Technical Service Bulletin

No.LA501-030V2
26
September 2006

Subject/Concern:	Discovery 3/LR3 - Washer Reservoir Leak

Models:		
Discovery 3 / LR3		VIN- range: Up to 6A408013

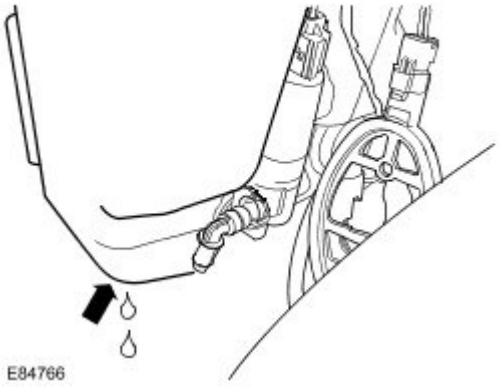
1 . Inspect the washer reservoir to confirm the leak is from the seam joint at the base of the washer reservoir.

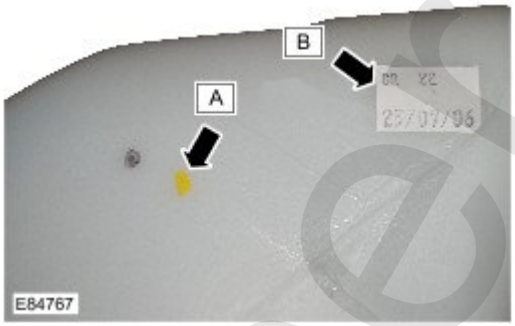
2 . **NOTE:** The new reservoir should be inspected prior to installation to ensure that a quality-controlled assembly is used. A quality-controlled assembly can be identified by the presence of a yellow paint pen mark on the side of the reservoir. If this is not present, check the date printed on a white label attached to the reservoir. The date of manufacture printed on the label must be after 25th July 2006.

Renew the windscreen washer reservoir. For additional information, refer to Global Technical Reference (GTR) Discovery 3/LR3 Workshop Manual Section 501-16, Reservoir - windshield washer, renew (84.10.03).
